PRODUCT CHANGE NOTIFICATION

E-Switch Series/ Part No affected: TL3253 series (all P/Ns)

Proposed change:

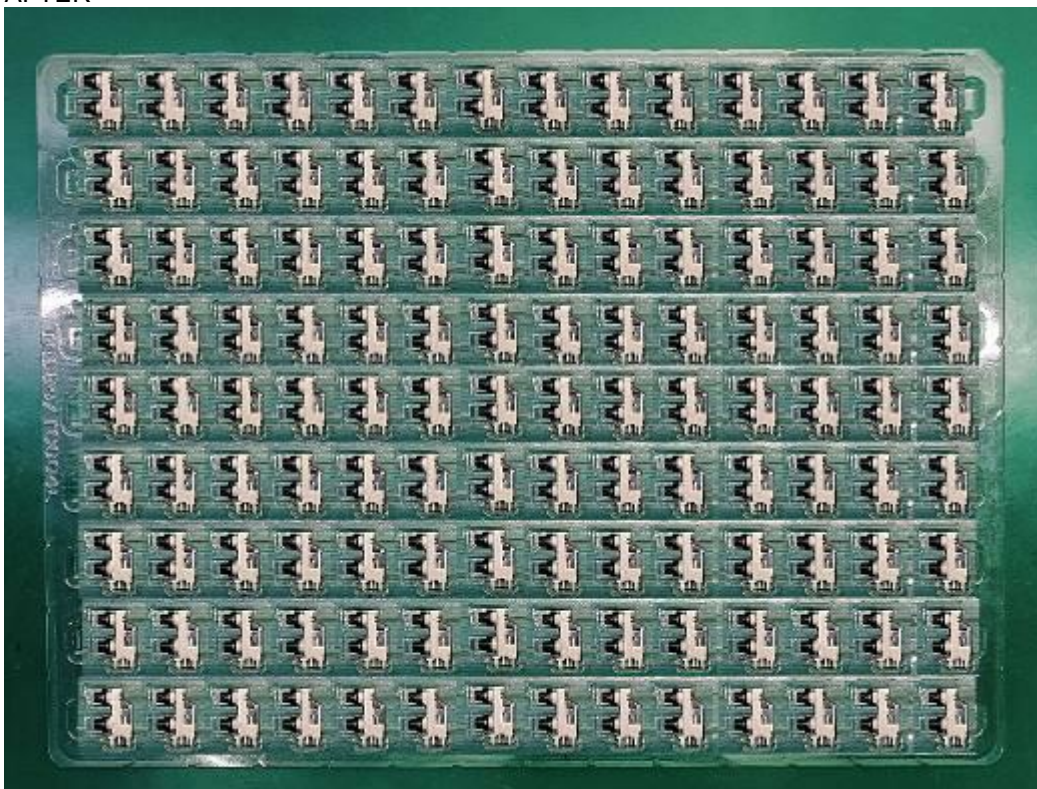
1. Improve packaging to prevent switch terminals from damage during shipping.
2. Package 1 piece per cavity instead of 2. New quantity per tray is 126.
